Re: CR 675 Crossings Supplemental Information

This memo is provided to supplement the CR 675 Crossings Preliminary Engineering Report dated December 22, 2020. During review by the project partners, several questions arose requiring further attention or explanation. This memo provides documented responses to those questions.

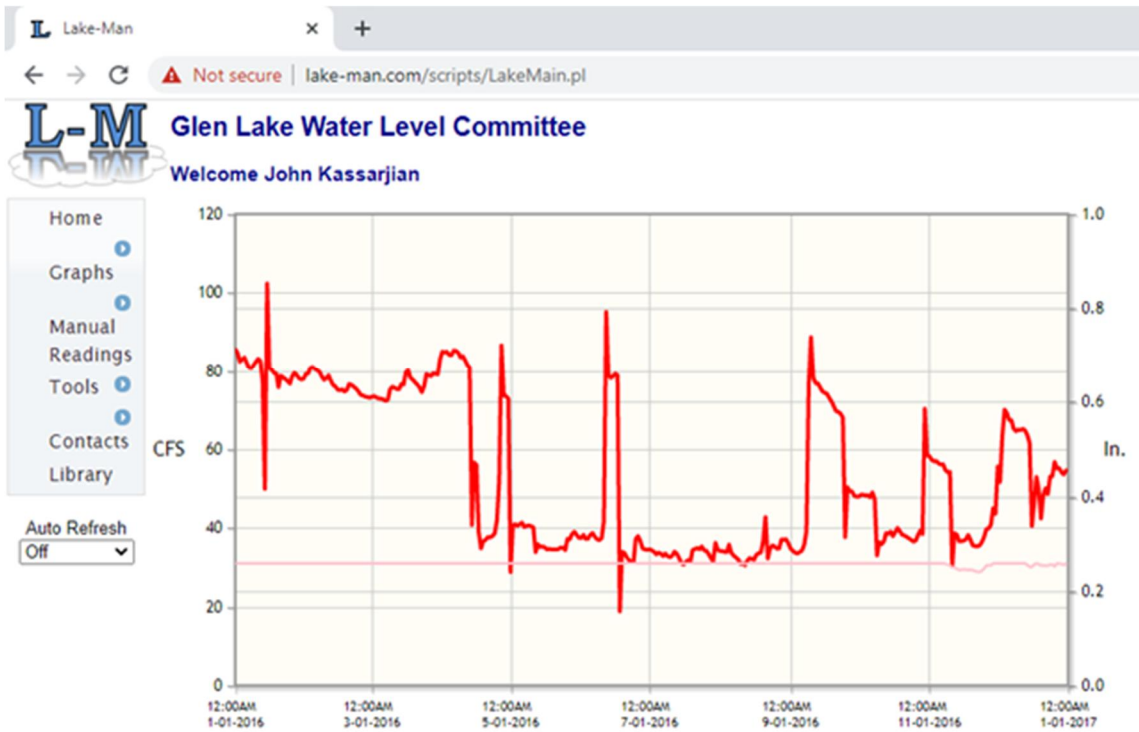
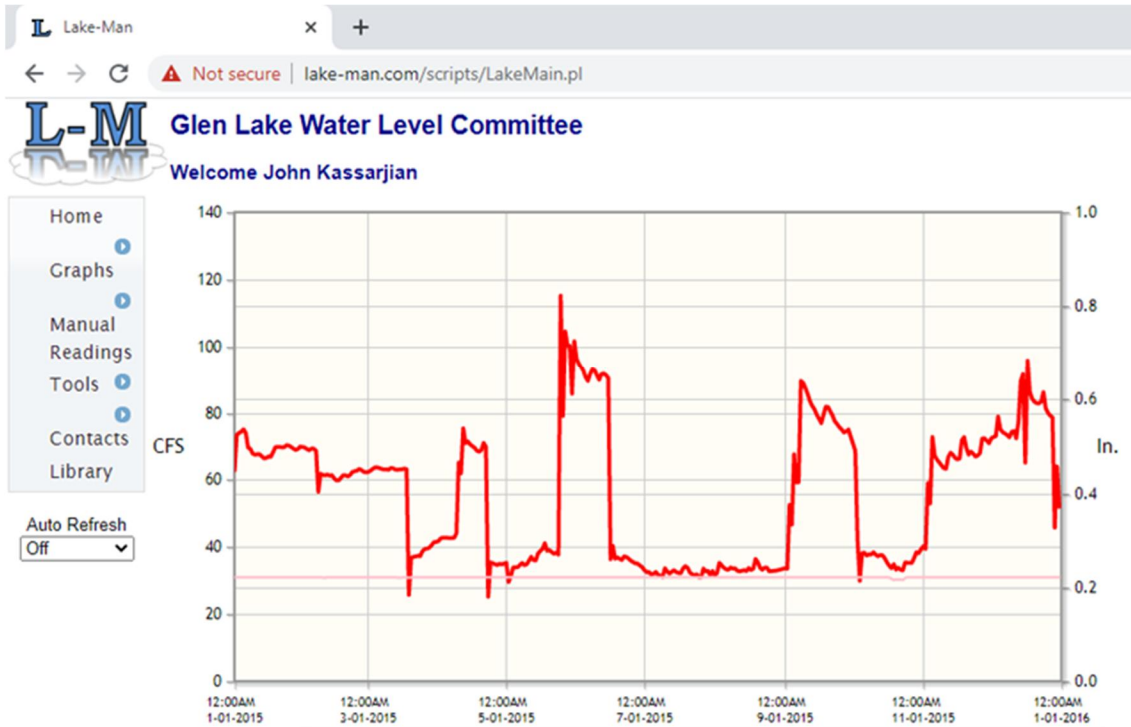
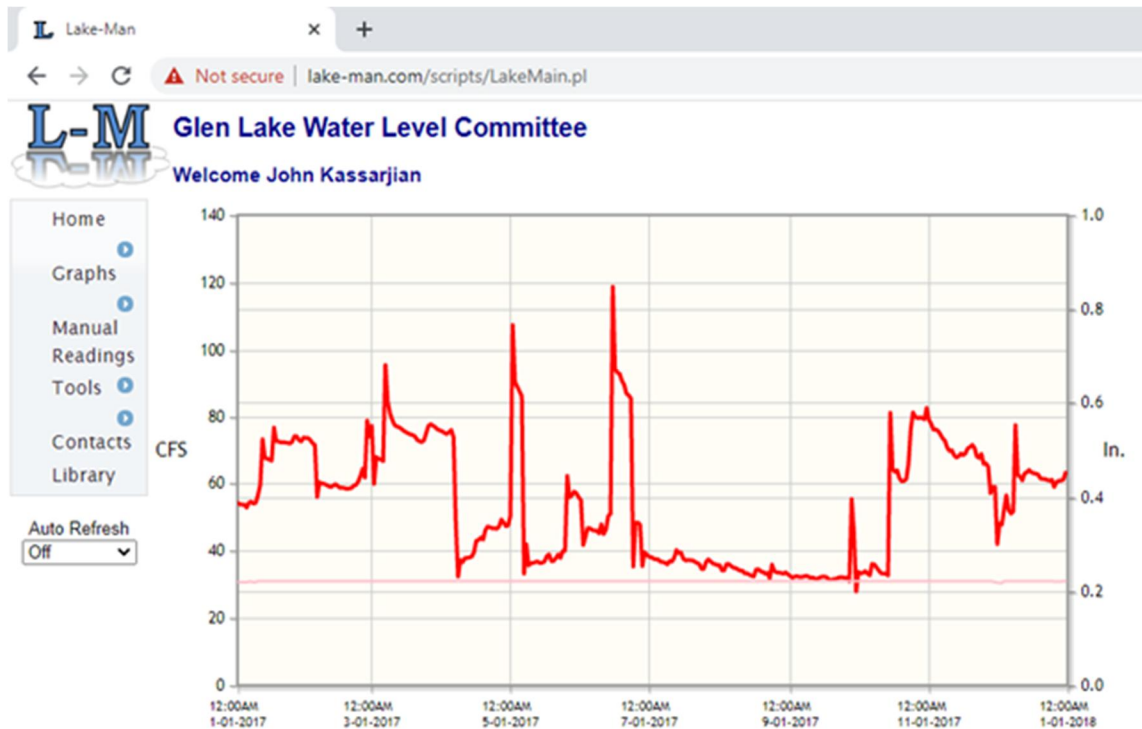
The original report notes the existence of extensive flow data collected over the years at the Fisher Lake Dam. The report also noted these flows generally in the 60-80 cfs range with peaks of 110 cfs and lows of 25 cfs. The data supporting this information was provided to us in graph form. The graphs from 2015-2017 are shown below.

It is also understood that a court ordered minimum flow of 31 cfs has been established for the Crystal River system. The court order also established the normal lake level of Glen Lake at 596.75. The dam is used to maintain Glen Lake’s lake level within a few inches of that elevation with the water level being slightly higher in the summer and slightly lower in the winter. These varying lake levels correspond to the higher and lower flows identified from the previous two sources as water is released in the winter for lower lake levels and retained in the summer for higher lake levels. The data from these available sources coupled with the court ordered minimum flow of 31 cfs corroborate the 35 cfs baseflow used in the HEC-RAS analysis as a valid estimate to be used with flood flows provided by EGLE for comparing changes between existing and proposed structures.
